New Albany Planning Commission Meeting Agenda

Planning Commission Staff Report November 17, 2025 Meeting

DUTCH BROS COFFEE SHOP FINAL DEVELOPMENT PLAN

RE: Dutch Bros Coffee – Final Development Plan, Conditional Use and Variance FDP-83-2025, CU-84-2025 and VAR-85-2025 9930 Johnstown Road

TRASH ENCLOSURE PLAN/ **ELEVATIONS**

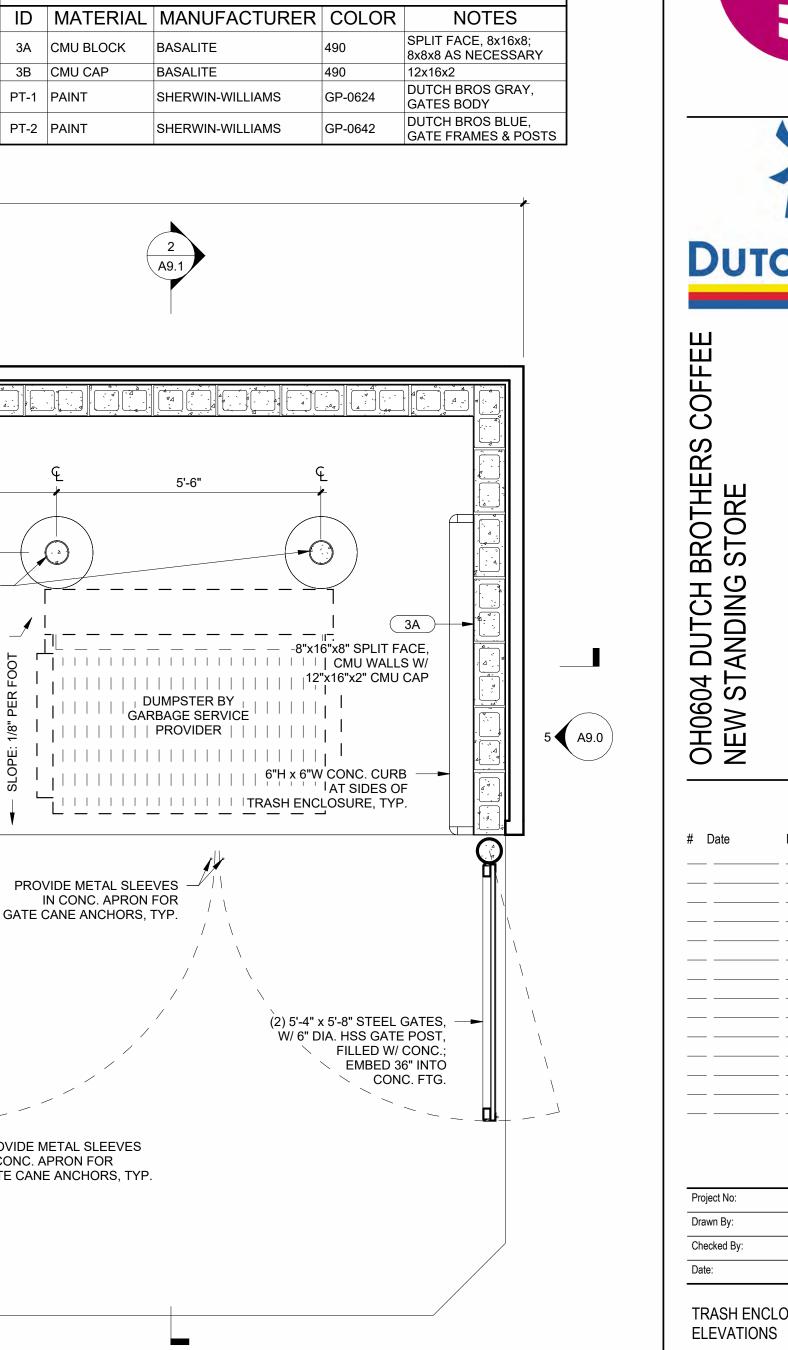
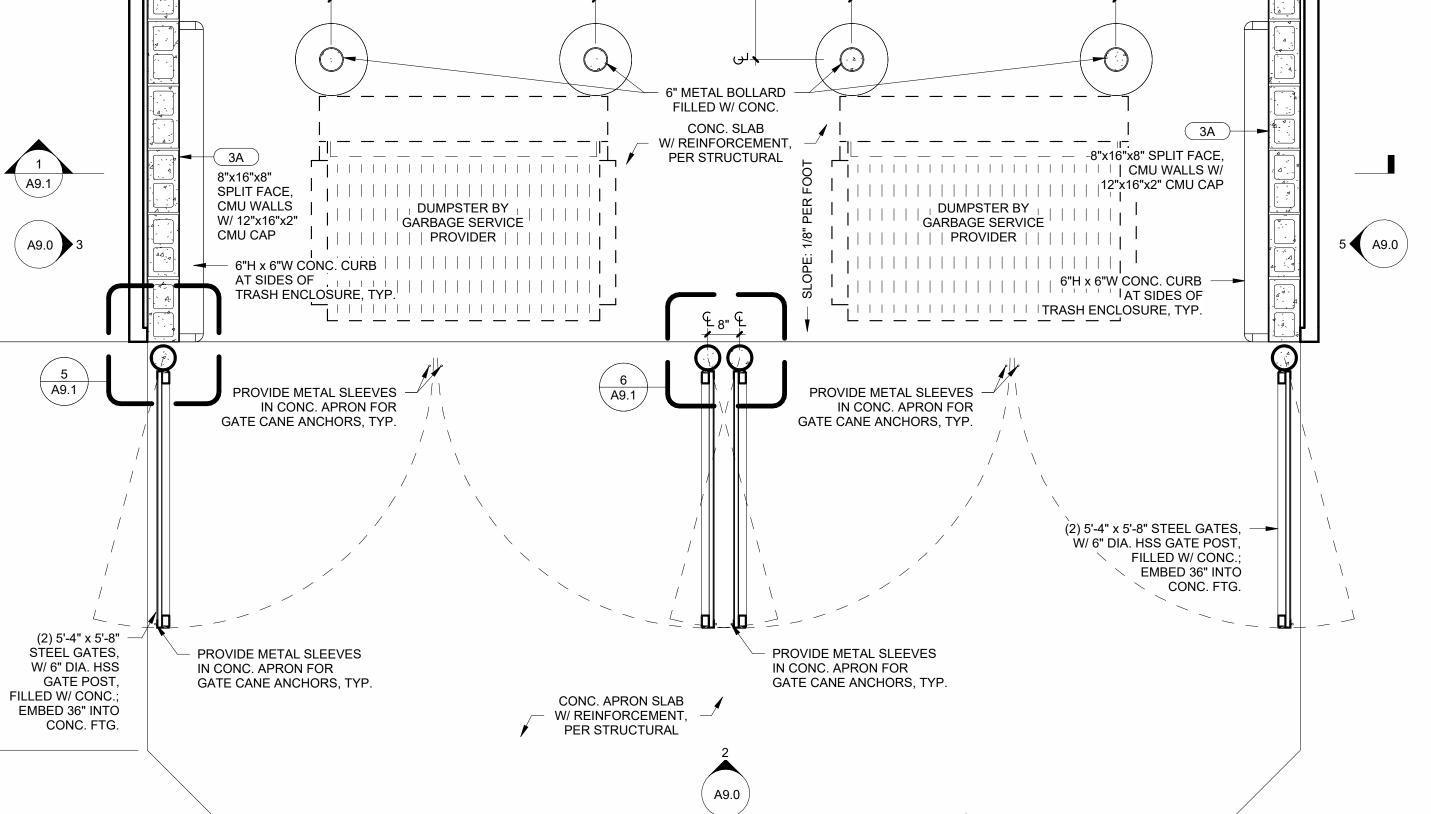
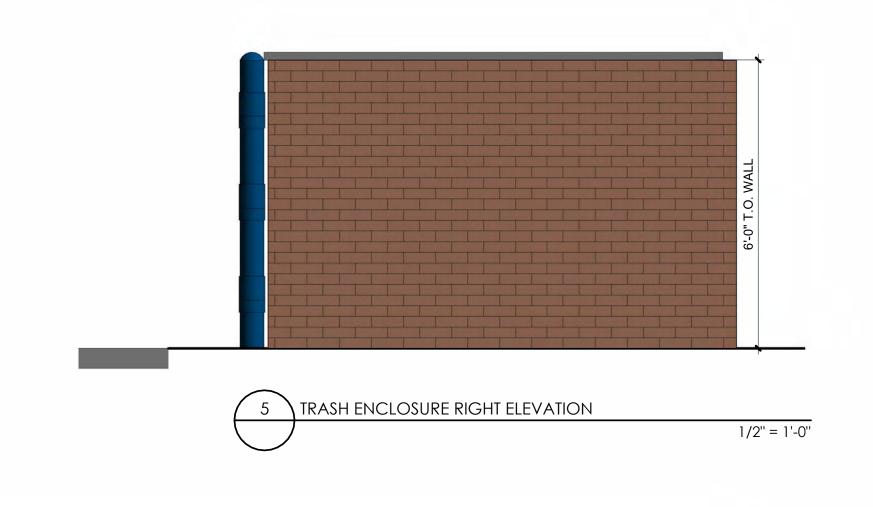
- Provide an elevation and/or details of the material, dimensions, etc. of the dumpster enclosure.
 Response: Trash Enclosure elevations have been provided, please see updated FDP set.

SIGN GUIDE

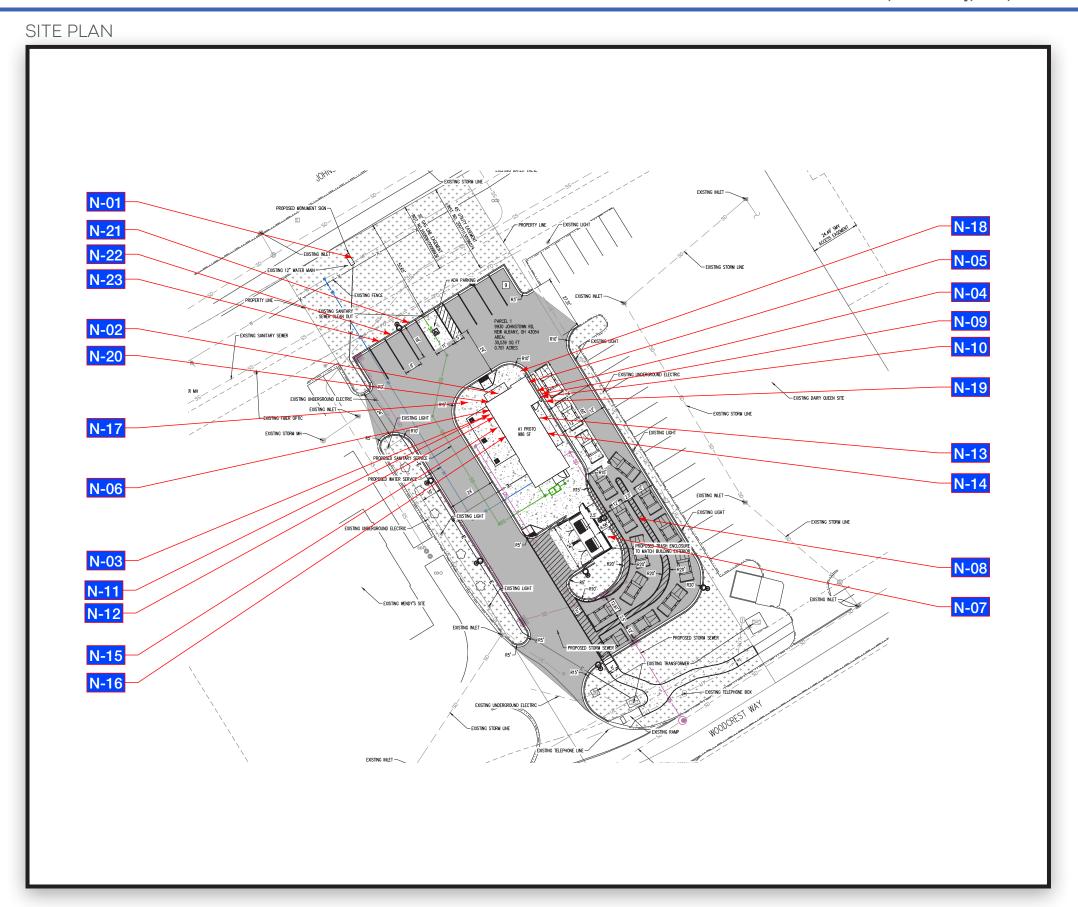
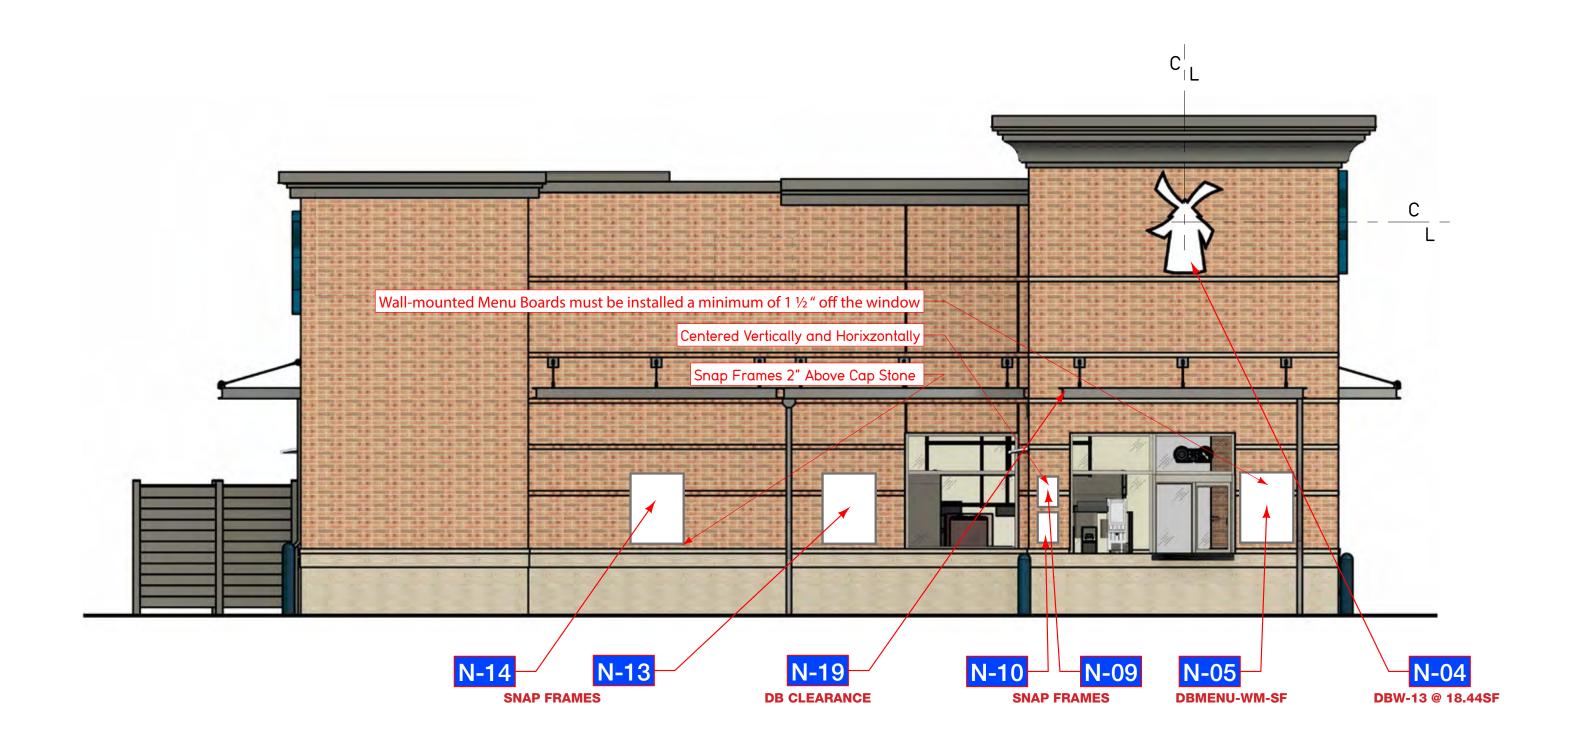
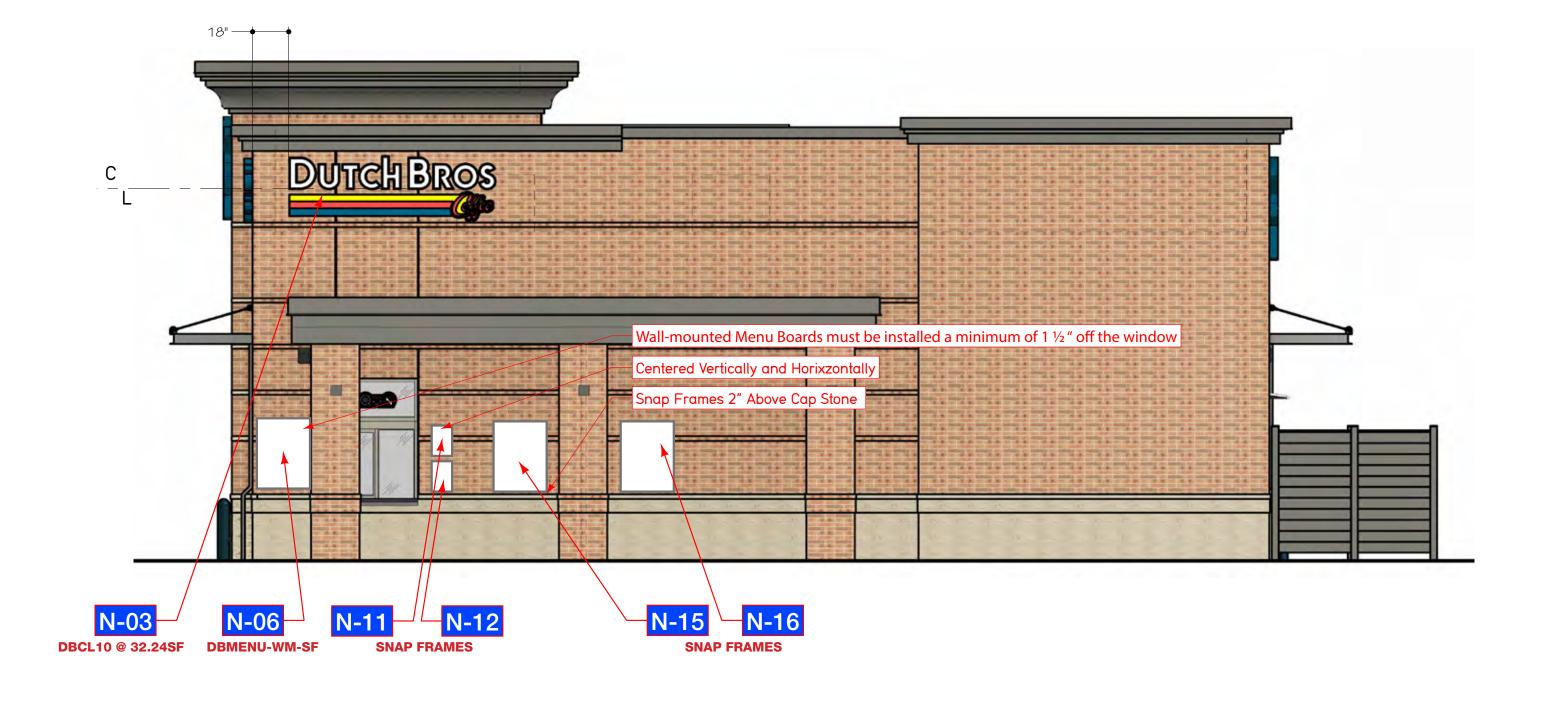
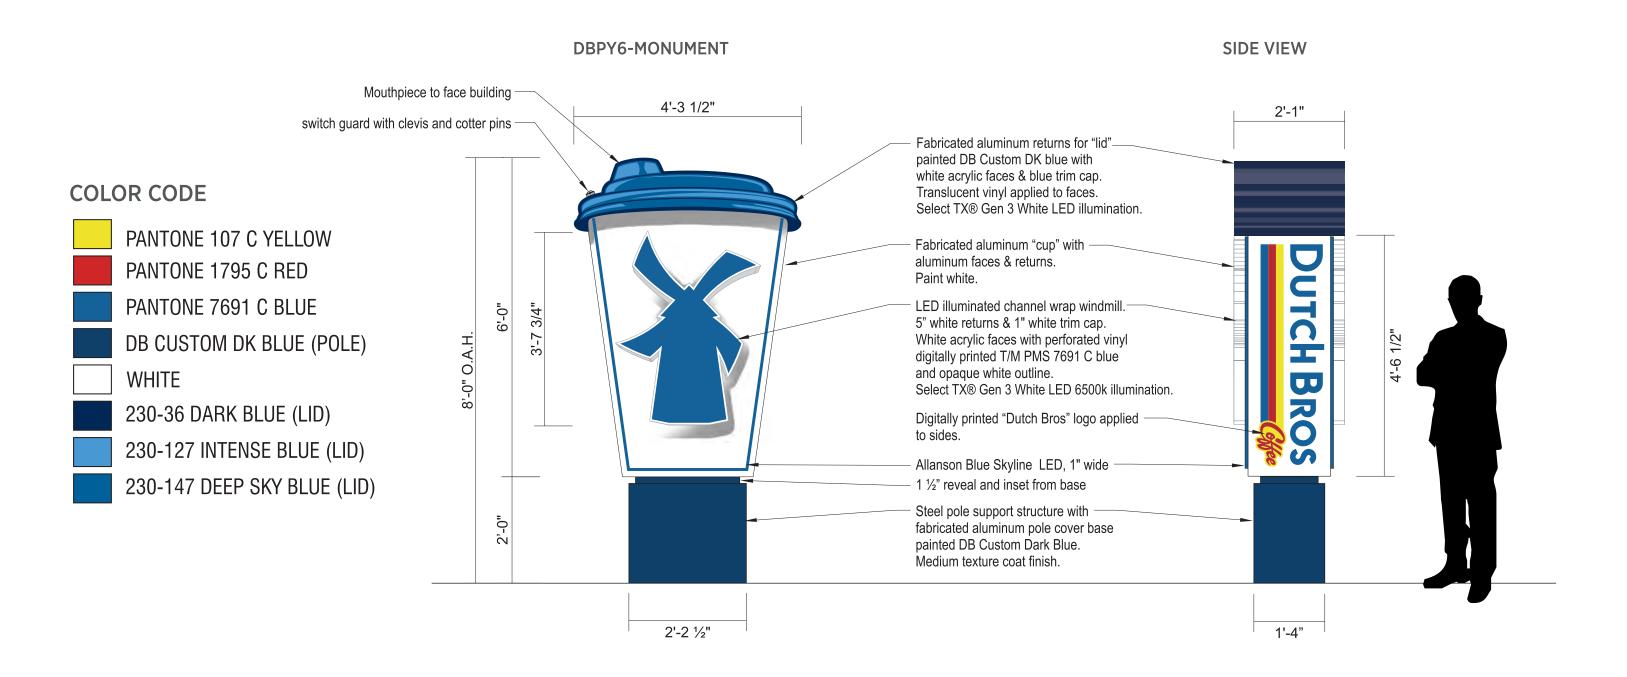
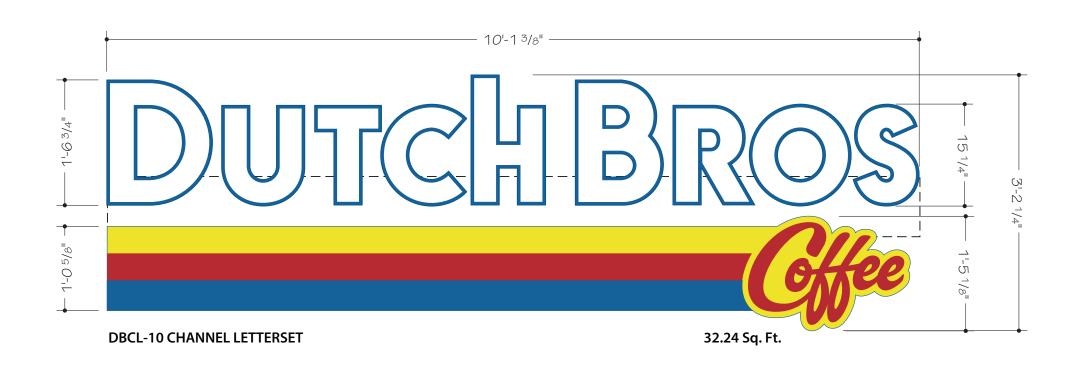
- 1. As part of this final development plan application, the applicant has submitted a sign plan for the site. The final development plan shows signage that differs from the sign plan package. Staff recommends a condition of approval that the proposed signage follow the specifications of the sign plan and not the final development plan (condition #7).

- 2. Zoning text section 8a.06(3)(i) permits one wall-mounted sign per retail tenant on each elevation of the building that fronts or sides on a public or private road. The proposed building faces two roads (one public road and one private road) and is permitted to use a total of two signs (one on each elevation facing a road). One square foot of sign face is permitted per each lineal foot of the building, not to exceed 80 square feet in size. The applicant proposes wall signs that do not meet location and quantity requirements and has applied for a variance to be heard by the Planning Commission at this meeting under case VAR-85-2025, item C. The applicant proposes the following wall signs:

- 7. Zoning text section 8a.06(3) and 8a.06(6)(h) prohibit signs from being internally illuminated. <u>The applicant proposes wall signs and a monument sign that are internally illuminated and has applied for a variance to be heard by the Planning Commission at this meeting under case VAR-85-2025, item E. SDEE</u>

- Staff feels the building may be "over-signed;" we recommend meeting the PUD standards, which say one sign is permitted on facades that face streets, which would be the front and back of the building only, and these would need only one sign. Otherwise, a sign variance can be added to the variance application.

- Response: Signage package provided by sign consultant, included with submittal along with a Variance request.
- Staff recommends adding "fake"/bricked windows to the side facades. Many of our design standards recommend or require buildings to have windows on all sides to appear more "lived in" and to help break up the façade, though this is not necessarily required.
